## ADDENDUM No. 3

### RFP No. 22-76

#### East Medical Center Drive Bridge Rehabilitation and Widening Project

DRAWING NO.  
**2021-008-STD10A**

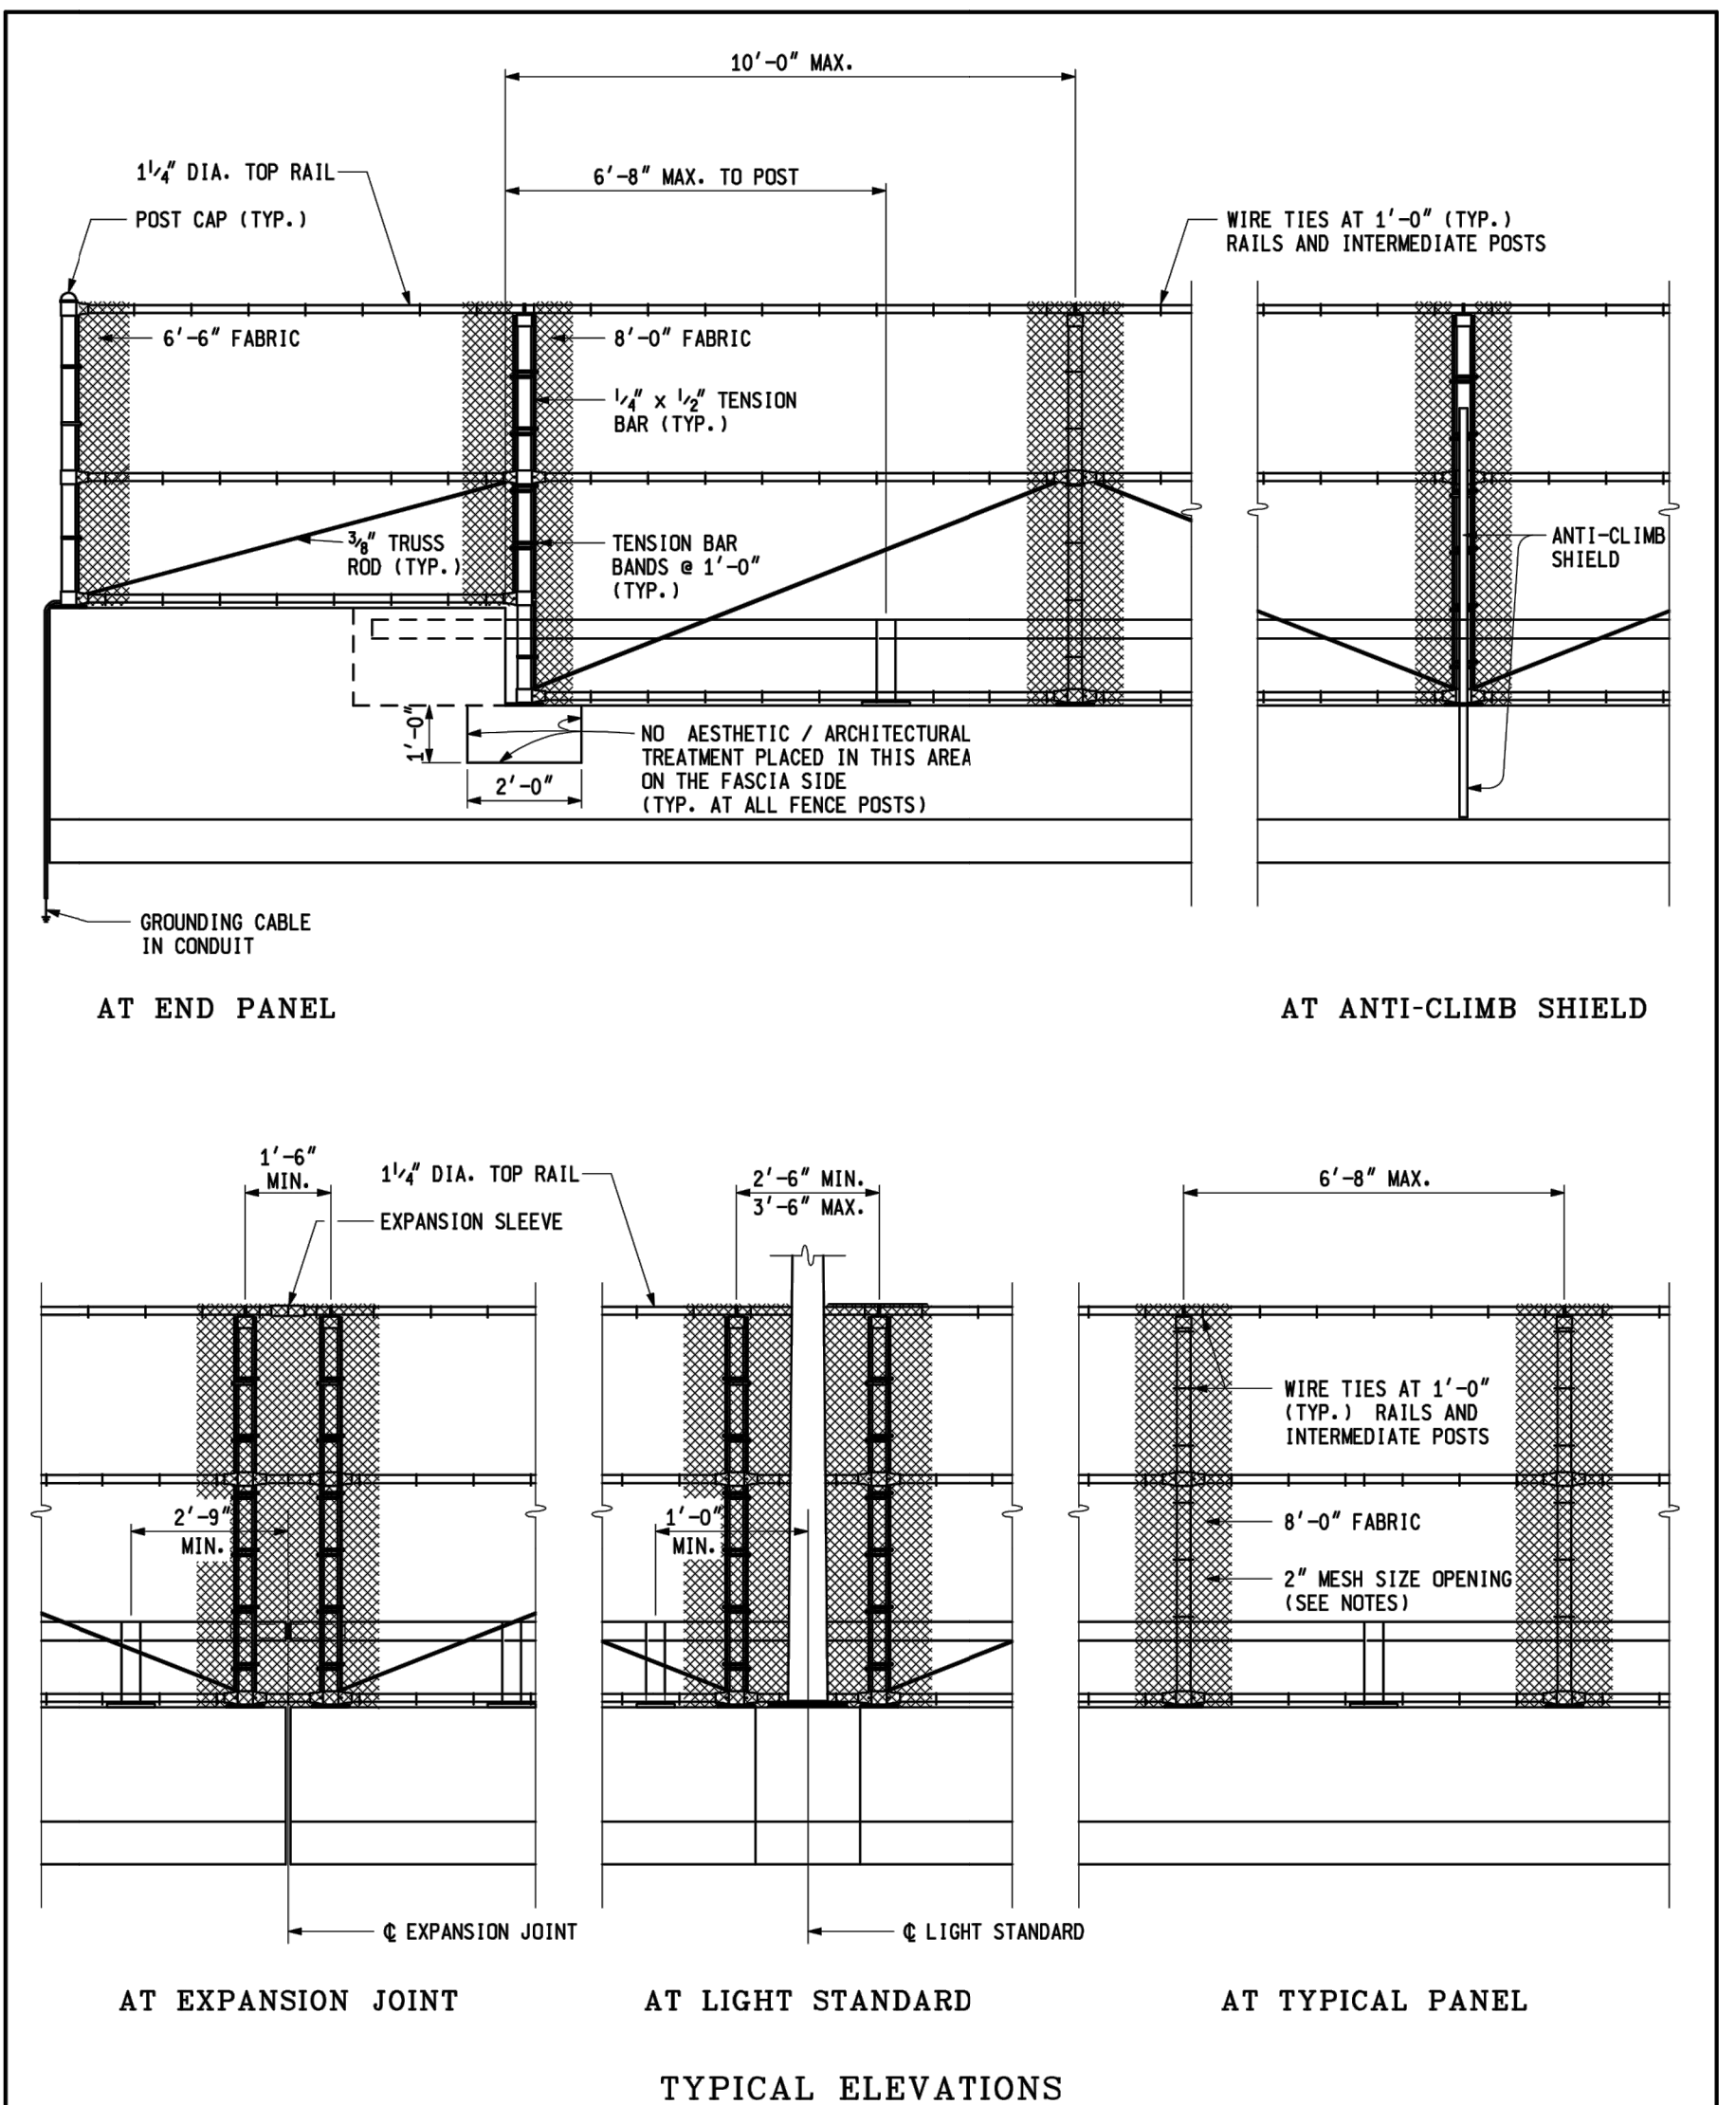
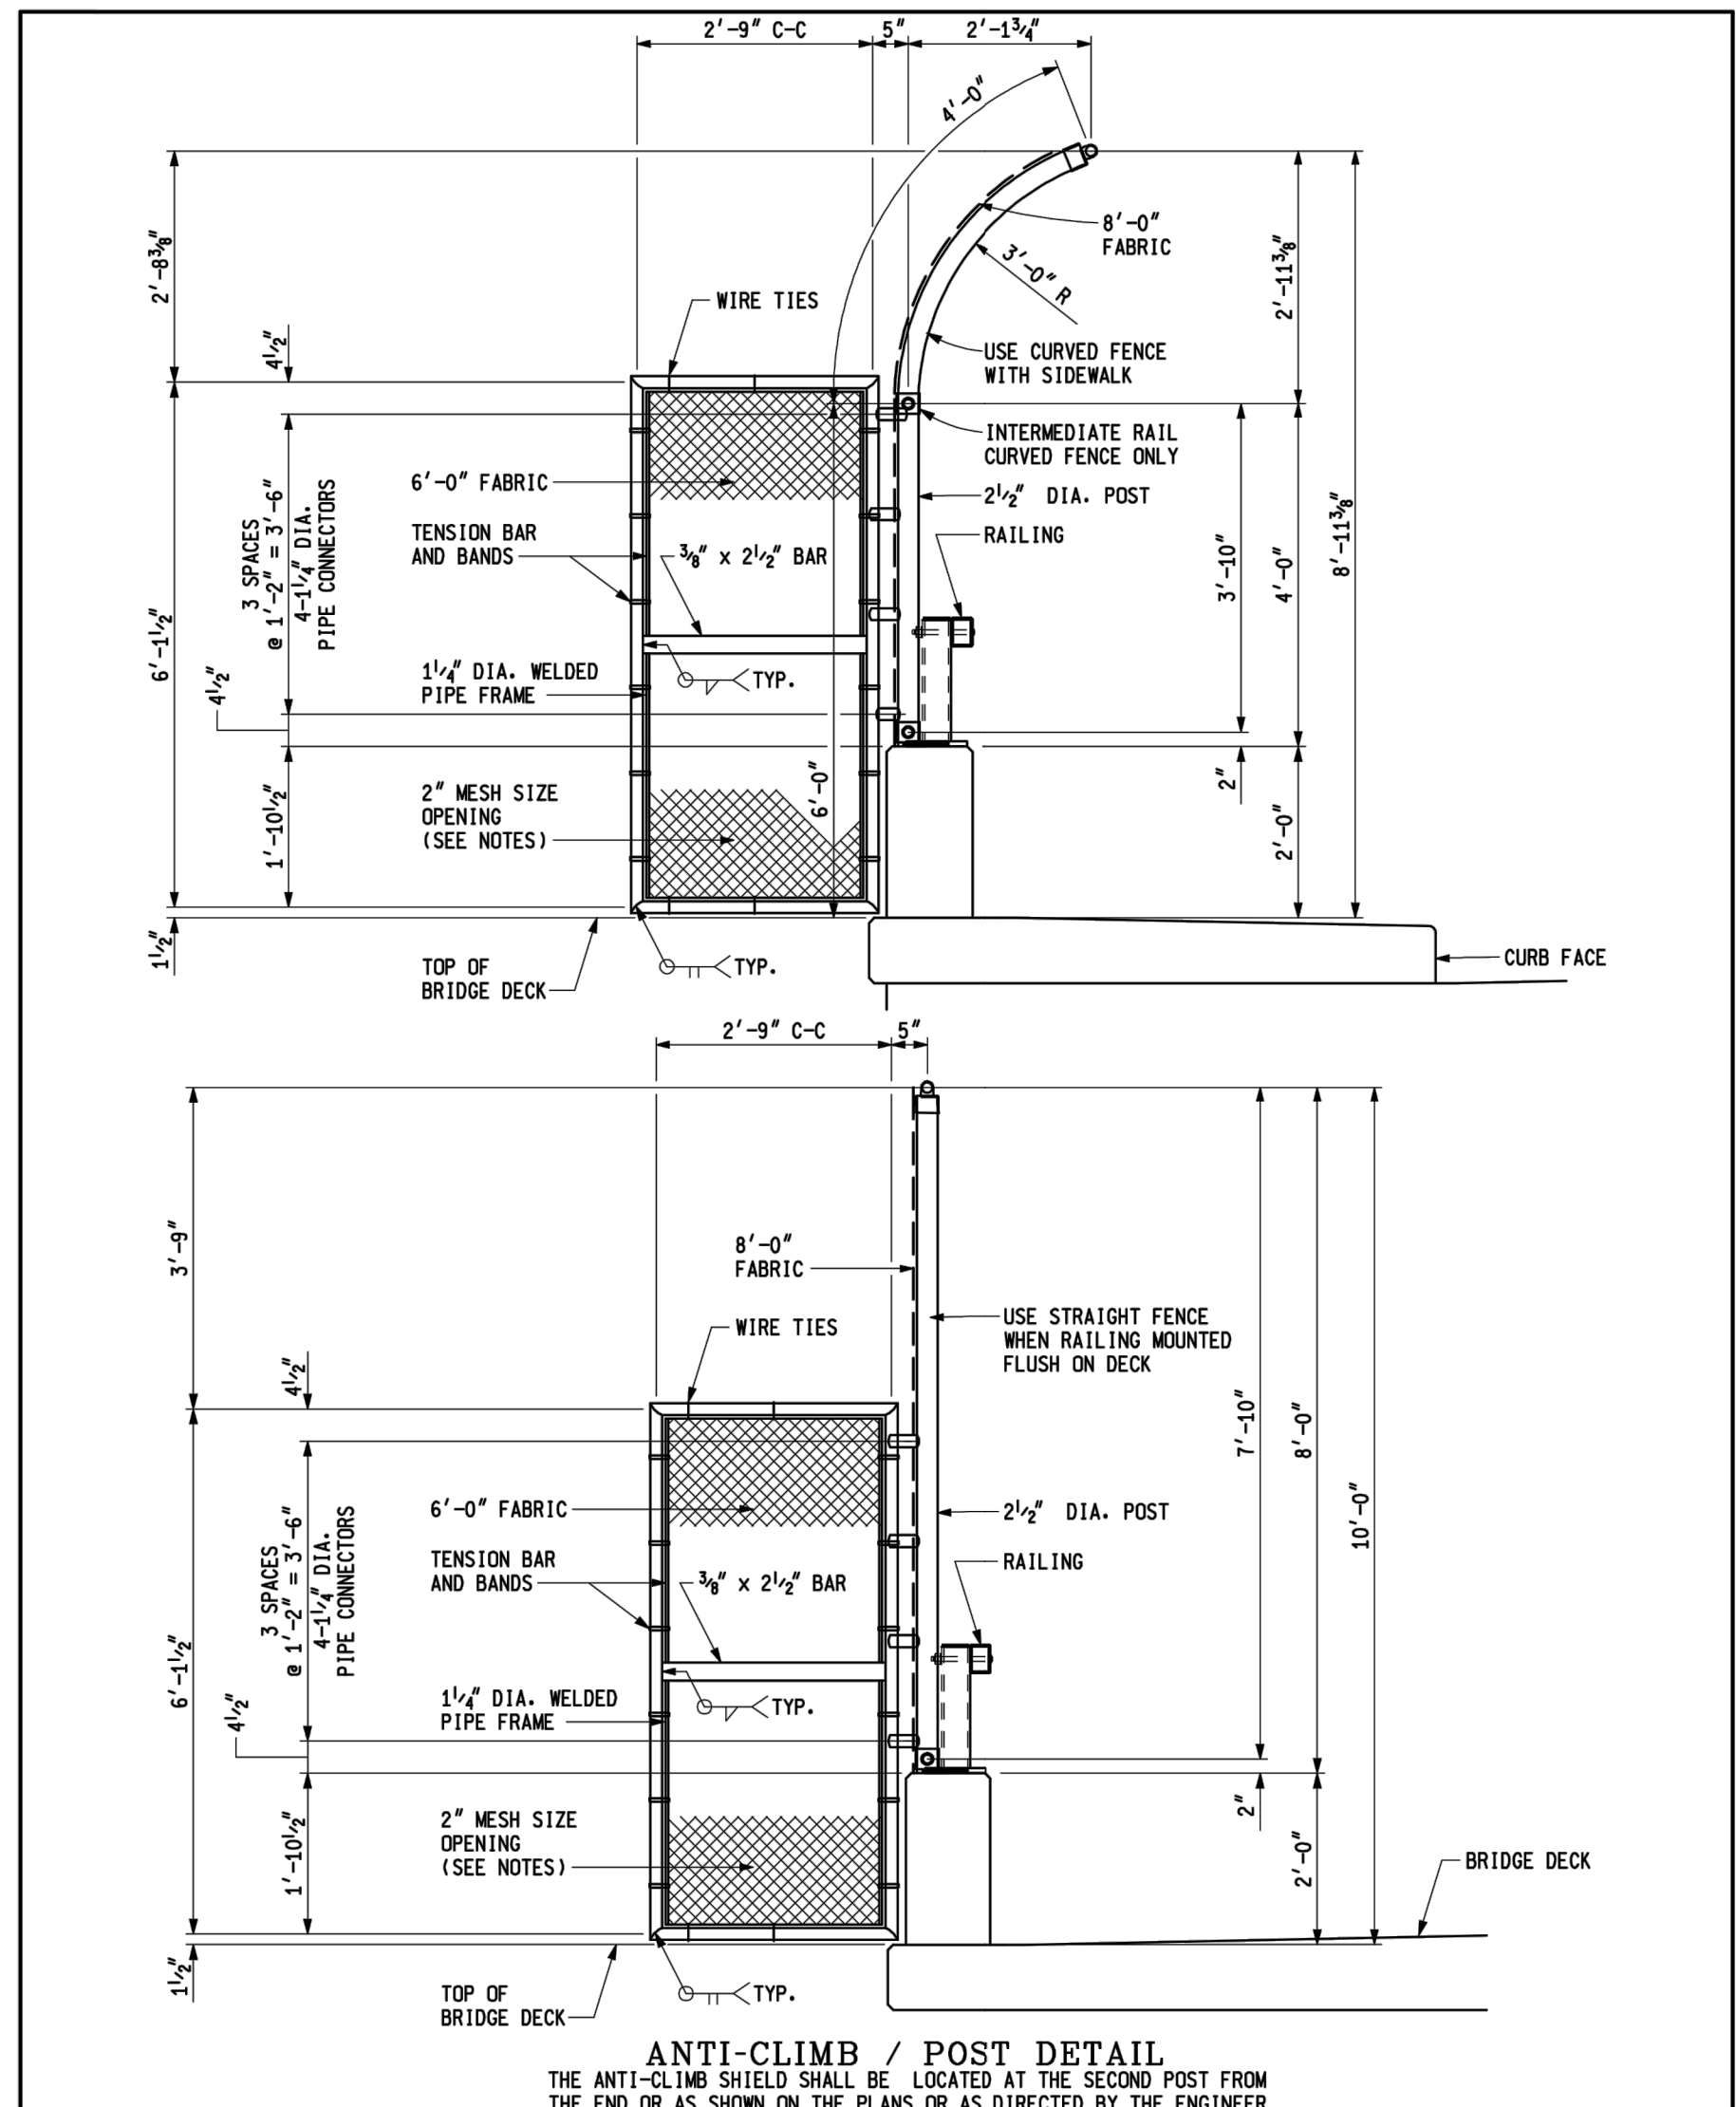
RFP\_22-76\_Plans Sheet 134A MDOT Standard Plan B-41-C Fencing for Bridge Railing, Aesthetic Parapet Tube was added to the plans.
